REMEDIATION SYSTEM EVALUATION

**SAVAGE MUNICIPAL WATER SUPPLY SUPERFUND SITE
MILFORD, NEW HAMPSHIRE**

Report of the Remediation System Evaluation,
Site Visit Conducted at the Savage Municipal Water Supply Superfund Site
March 22-23, 2001

Final Report Submitted to Region 1
September 17, 2001

FIGURE 1-2. THE SLURRY WALL AND COMPONENTS OF THE OU1 REMEDIATION AND MONITORING SYSTEMS

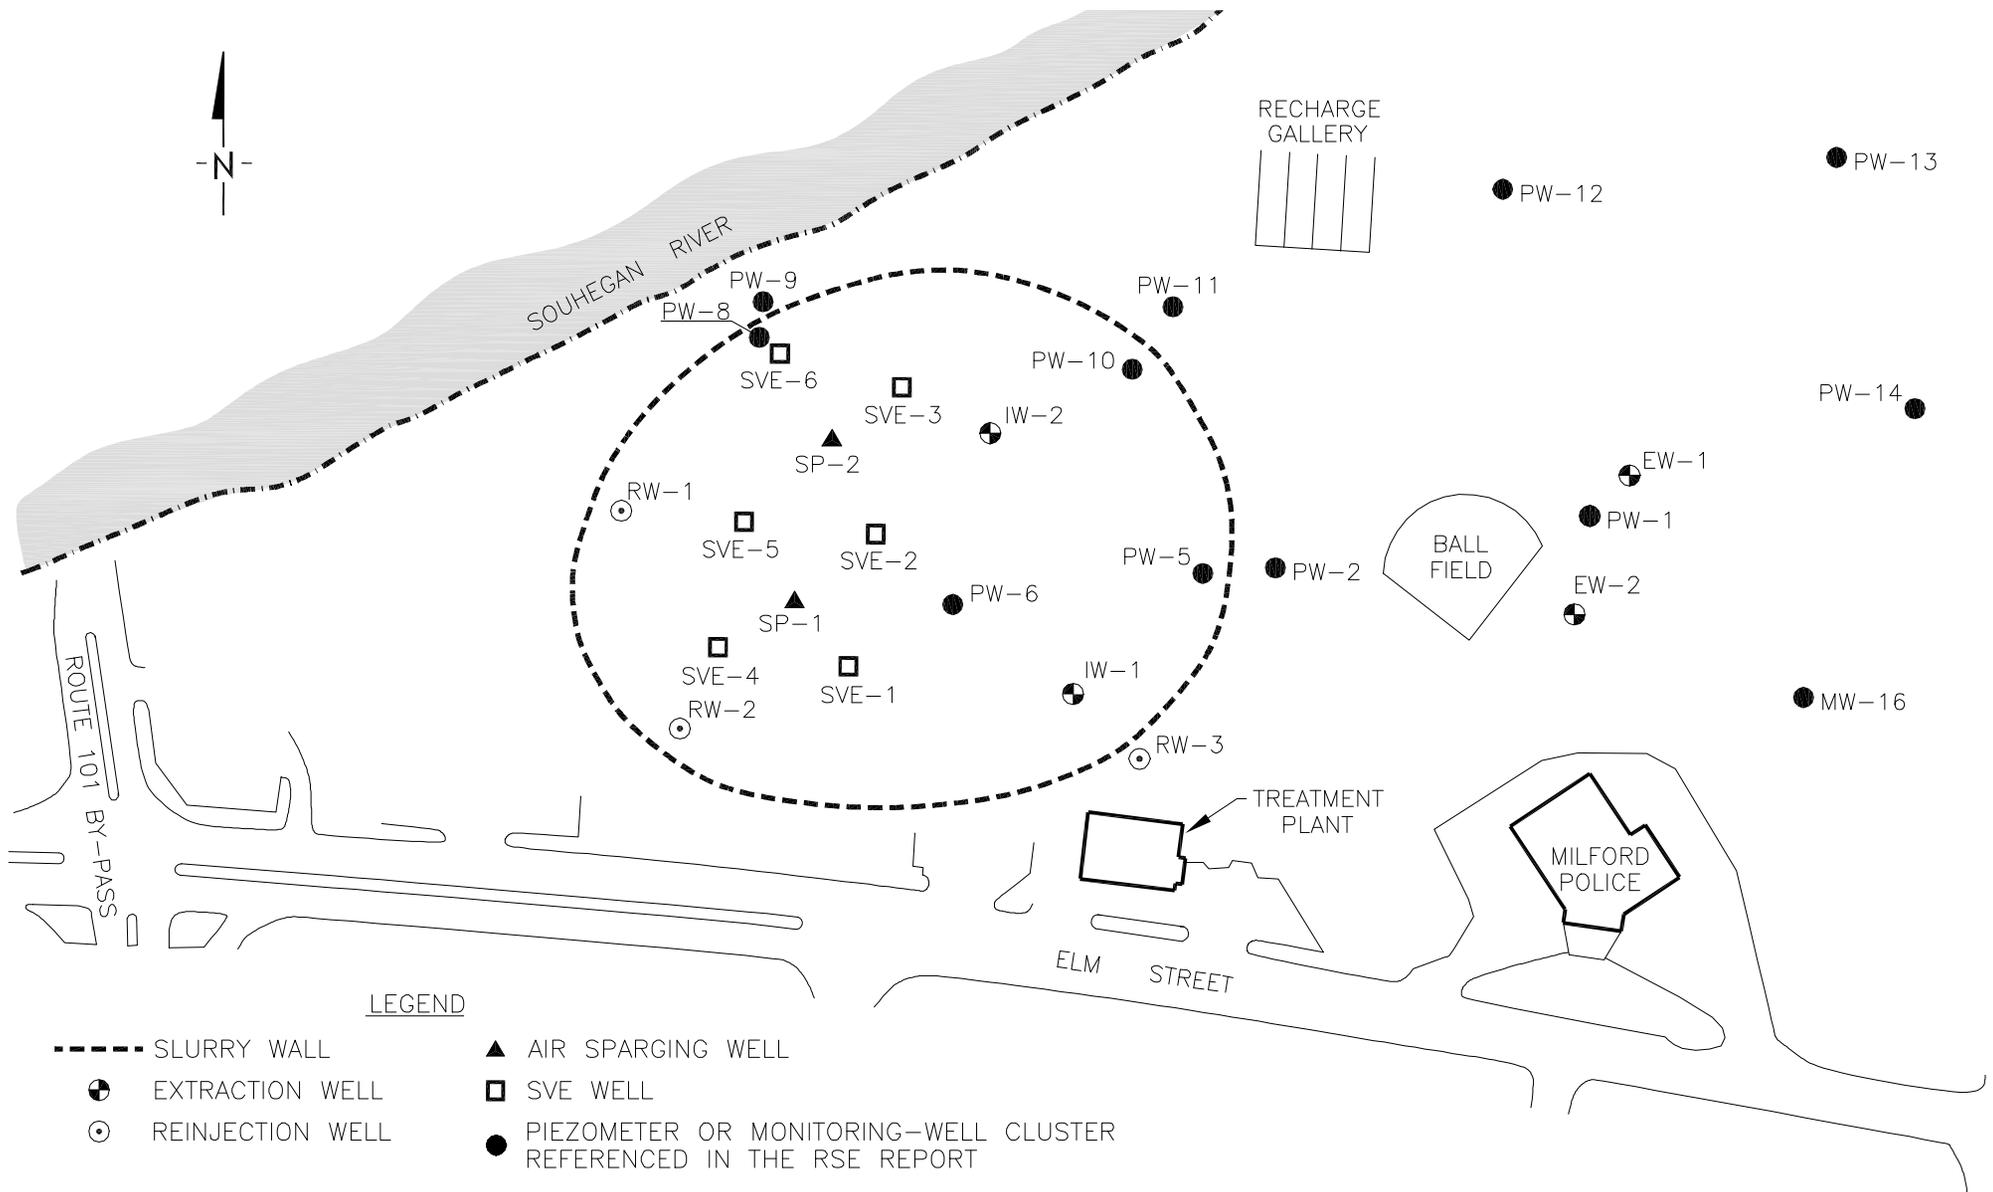
The capture zones of EW-1 and EW-2 should be evaluated to ensure their operation meets the requirements of the remedy in the most efficient manner possible. Additional investigation and evaluation of the present contaminant masses and the recovery hydraulics is necessary to attain the maximum effect of the recovery and recharge system.

To evaluate the capture zones of EW-1 and EW-2, plume maps should be generated semi-annually as aquifer VOC samples are collected and potentiometric surface maps should be generated monthly as water levels are measured. Each quarter, the most recent plume map should be compared to the potentiometric surface maps generated during that quarter. For capture of the plume, hydraulic gradients should indicate flow toward the extraction wells for all areas of the plume. An initial cost of \$15,000 may be required to generate CADD site maps and previous plume and potentiometric surface maps. Generating these maps with data collected in the future and interpreting them in a quarterly report may increase annual costs by approximately \$4,000 per year. It should be noted that if the potentiometric surface maps are not sufficiently resolved to determine the capture zone, the USGS model of the site may be helpful in capture zone analysis.

In addition to measuring and interpreting the water levels, the PCE concentrations from the PW-12, PW-13, PW-14, and MW-16 clusters should be tracked over time. If the capture offered by EW-1 and EW-2 is sufficient, then concentrations in these sampling points should decrease. Previous PCE concentration trends in these sampling points indicate at least partial capture.

Currently, the operator is using only the INEEL well to gauge the containment offered by the slurry wall. While this offers a method of determining the water level at one point within the wall, it does not accurately determine the hydraulic gradient across the wall boundary. Rather, containment should be determined from the hydraulic gradients obtained from measuring water levels weekly in the following piezometer pairs: PW-10M and PW-11M, PW-5M and PW-2M. Extraction rates from IW-1 and IW-2 should be adjusted weekly such that the hydraulic gradients evaluated from these water-level measurements ensure flow directed into the area enclosed by the wall.

Water levels measured from these piezometers on September 6, 2000 suggest containment at these locations with the exception of the deep portion of the glacial outwash and bedrock screened by PW-5(D and R) and PW-2(D and R). This may present an avenue for contamination to be transported beyond the source area enclosed by the slurry wall.

Additionally, to determine the effectiveness of the slurry wall, a pumping test should be conducted by extracting water from IW-1 and IW-2 at 25 gpm for 48 hours and measuring the time-varying response of the water levels in the following piezometers: PW-8M, PW-9M, PW-10(M and D), PW-11(M and D), PW-5(S, M, D, and R), PW-2(S, M, D, and R). The wall is effective if water levels in piezometers PW-9M, PW-11(M and D), and PW-2(S, M, D, and R) have a significantly reduced response compared to the water levels in piezometers PW-8M, PW-10(M and D), and PW-5(S, M, D, and R). The cost of conducting and analyzing this pumping test is approximately \$30,000.
